ADDENDUM NO. 1

April 14, 2022

YOST ELEMENTARY SCHOOL ADDITIONS AND RENOVATIONS Chesterton, IN 46304

Addendum One (AD.01) to the drawings and specifications prepared by Gibraltar Design for **New Yost Elementary School** for Duneland School Corporation, Chesterton, Indiana.

SHEET
MV106

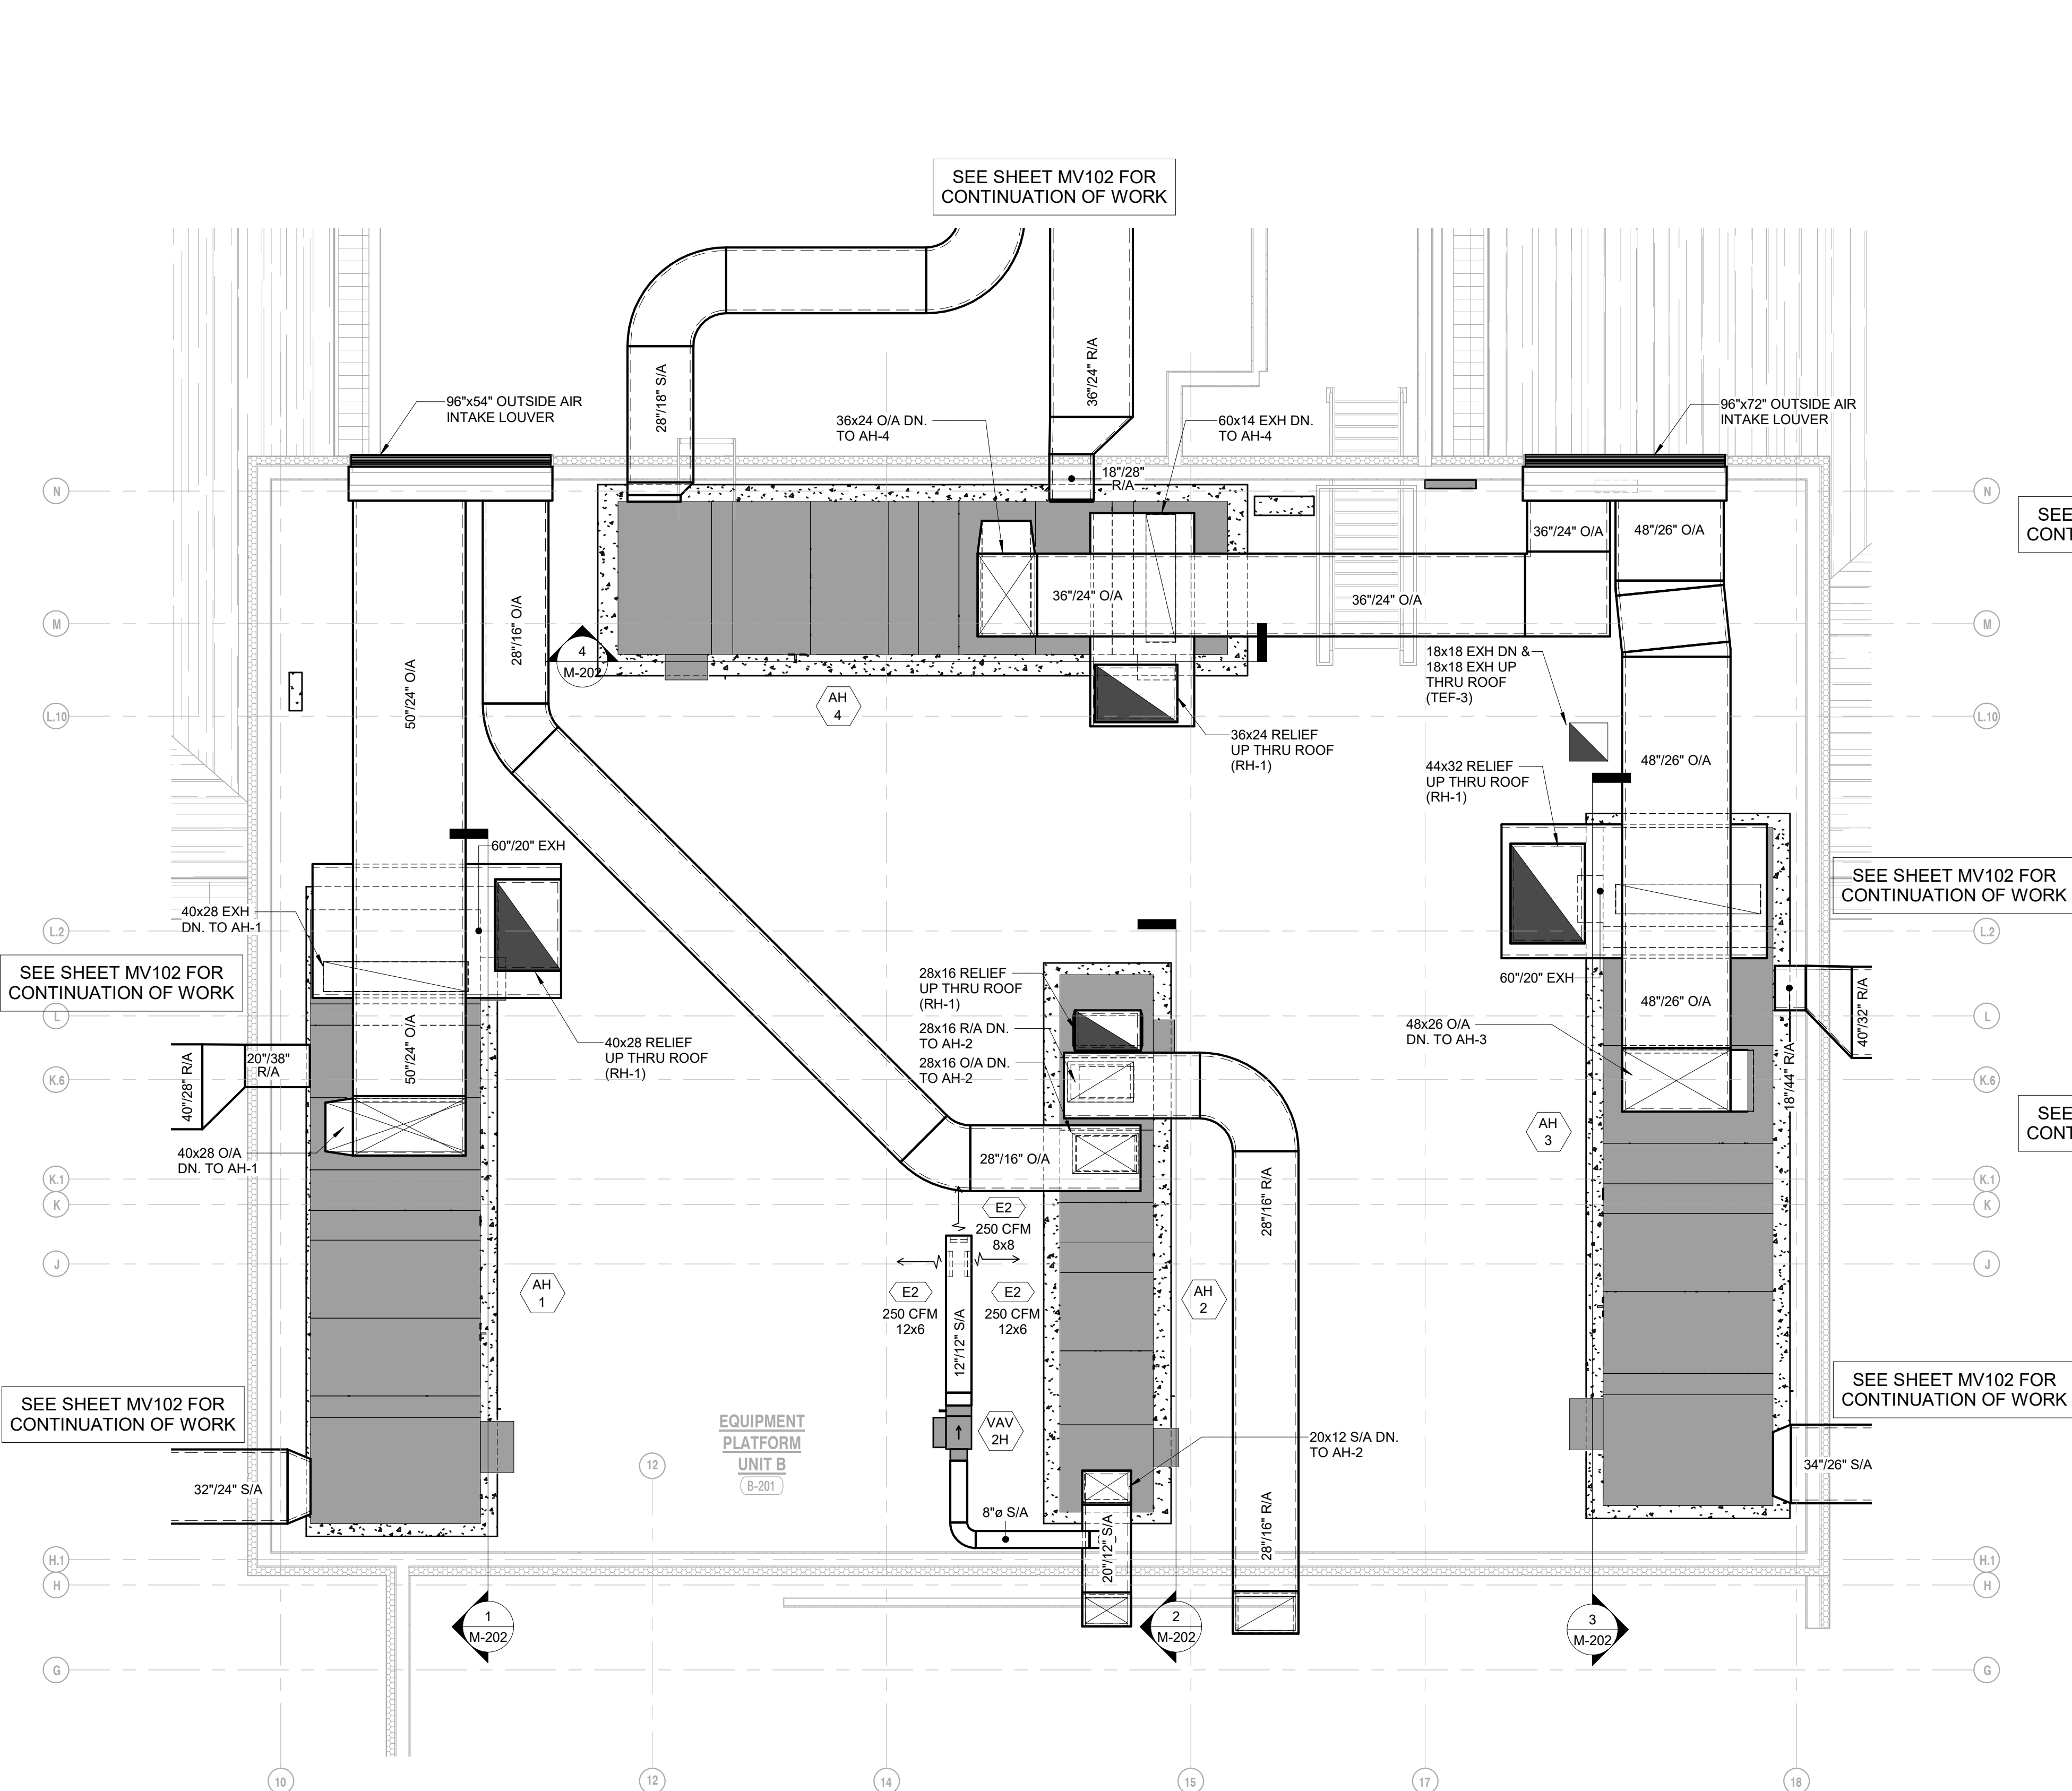
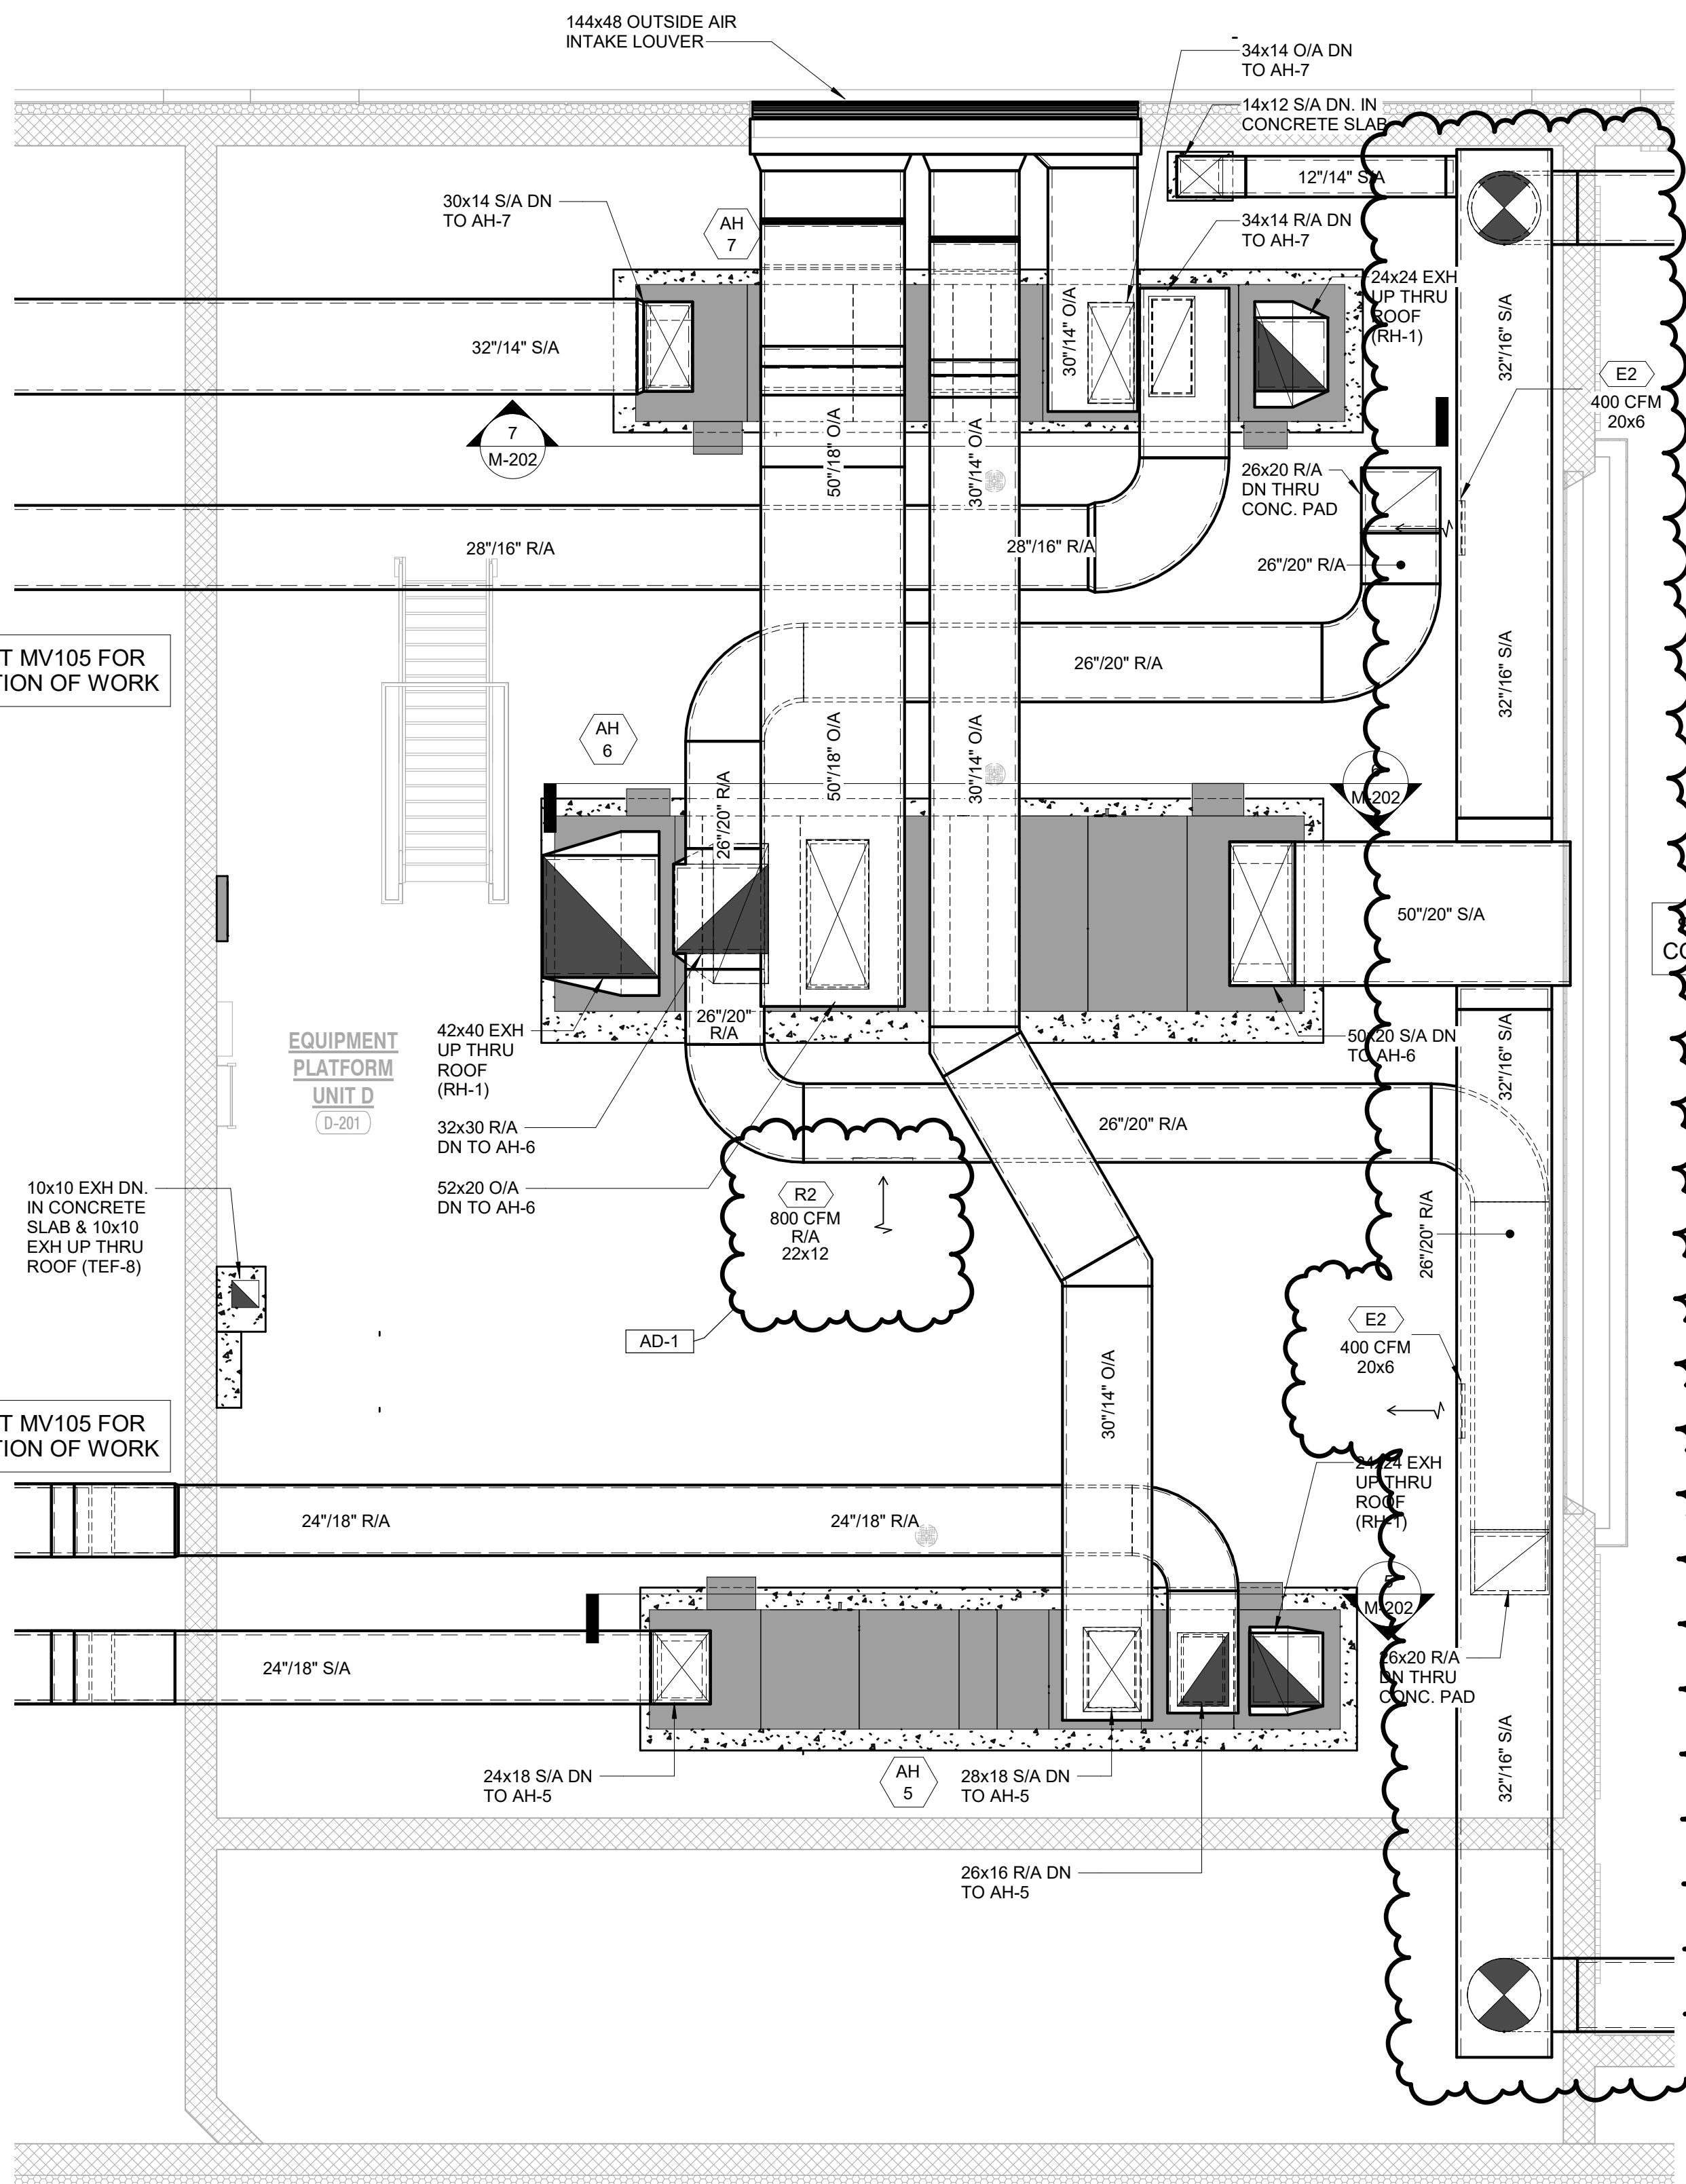
32. Sheet MV106

- A. Refer to revised full size drawing, included in this Addendum, for the following revisions:
 1. Added VAV-2H to B-201.
 2. Updated ductwork routing for AH-6.

MP101

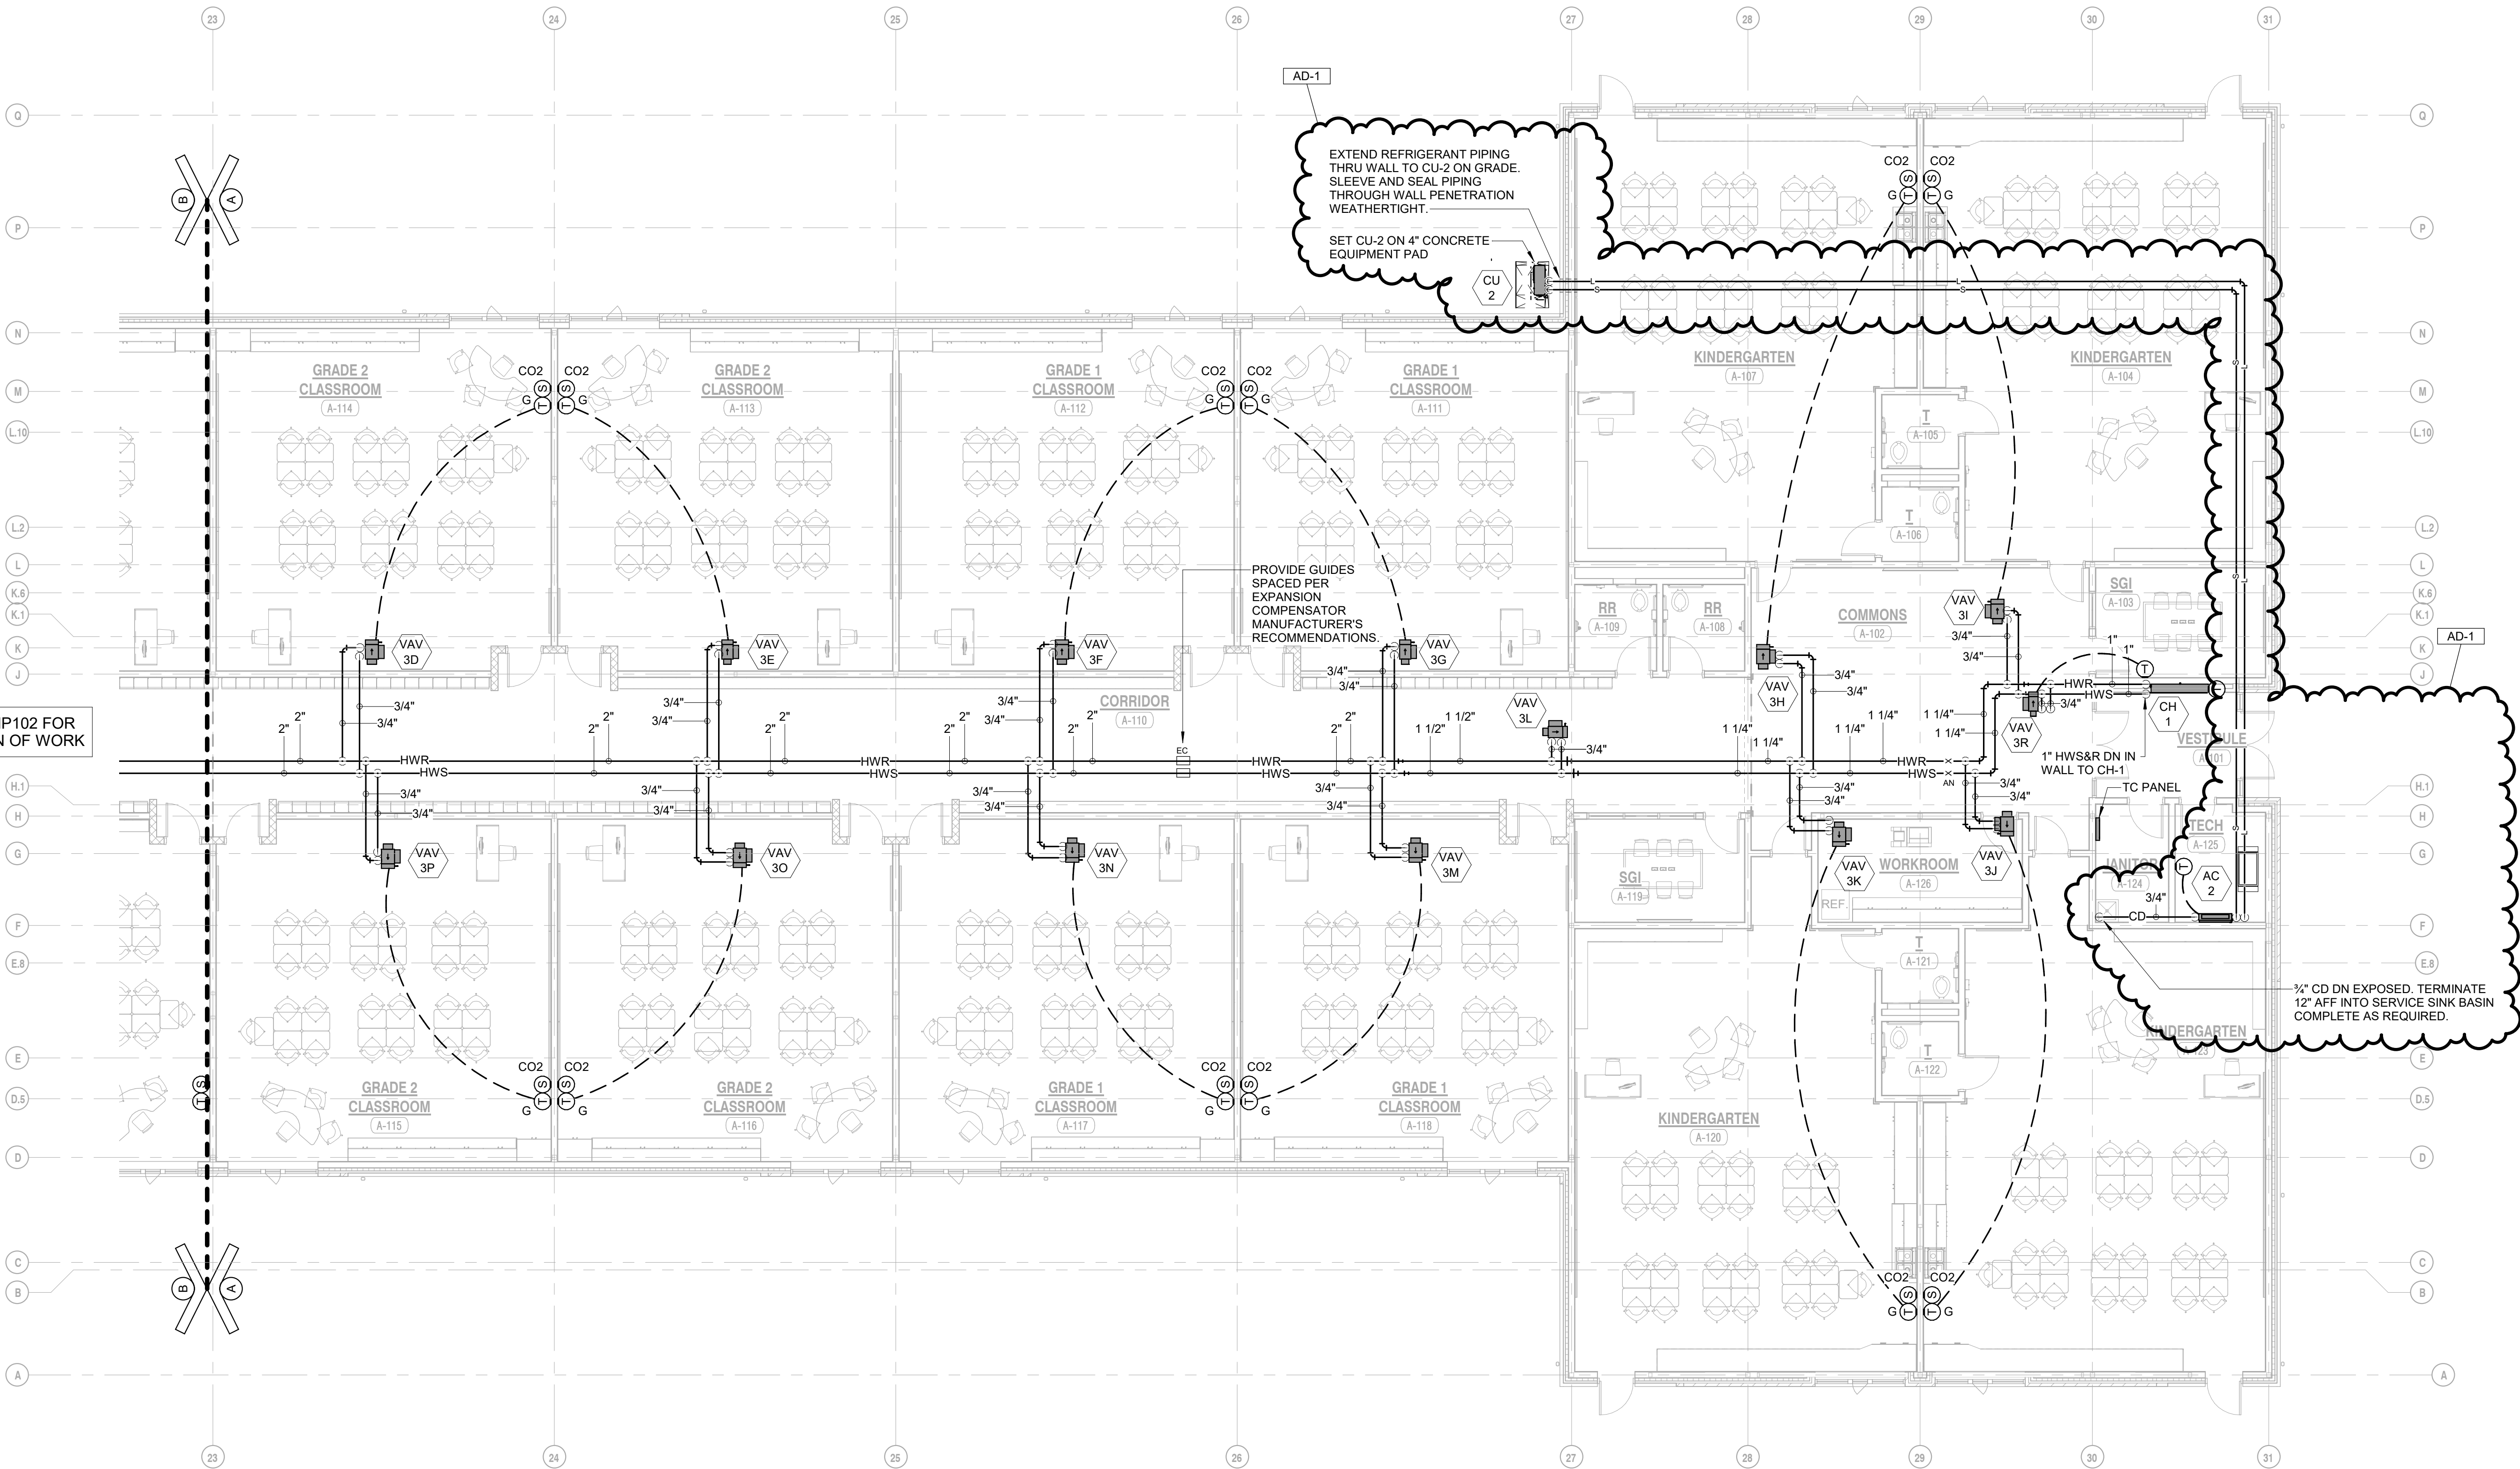
33. Sheet MP101

- A. Refer to revised full size drawing, included in this Addendum, for the following revisions:
 1. Relocated CU-2 to north side of building and rerouted associated refrigerant piping.
 2. Revised condensate piping to terminate in Janitor A-124.
